Appendix C:

Disposition Tables of Responses to Comments Received from Federal Reviewers on Provincial Technical Reports

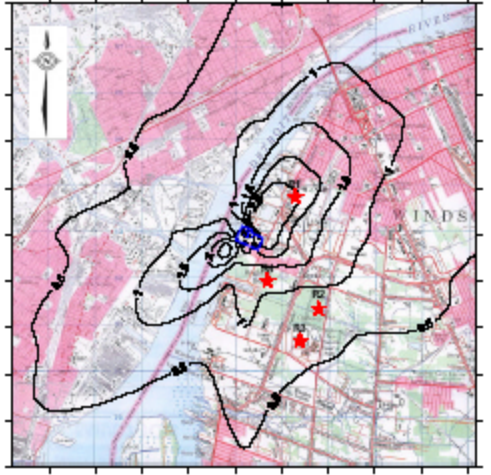
Agency	Comment Received	Action
		<p>and the maximum concentrations of PM_{2.5} are not likely to be detectable from the daily background variability using conventional monitoring equipment.</p> <ul style="list-style-type: none"> As stated in the BBPP report, <i>the predicted incremental concentrations of SO₂, CO, SPM, and PM₁₀ are only a small fraction of the ambient concentrations measured in Windsor. For these constituents, no measurable increase in ambient concentrations should be experienced.</i> <p>No additional modelling is required to determine the impacts.</p> <p>Figure 4.1 and Table 4.3 from Environmental Review Report for the Brighton Beach Power Station, December 2001.</p> <p>Information on Brighton Beach Power Plant has been added into Table 7.1 Identification of Other Projects and Activities in the CEA of the CEAA</p> <p style="text-align: center;">FIGURE 4.1 PREDICTED INCREMENTAL ANNUAL AVERAGE NO_x CONCENTRATIONS</p>  <p>Report.</p>
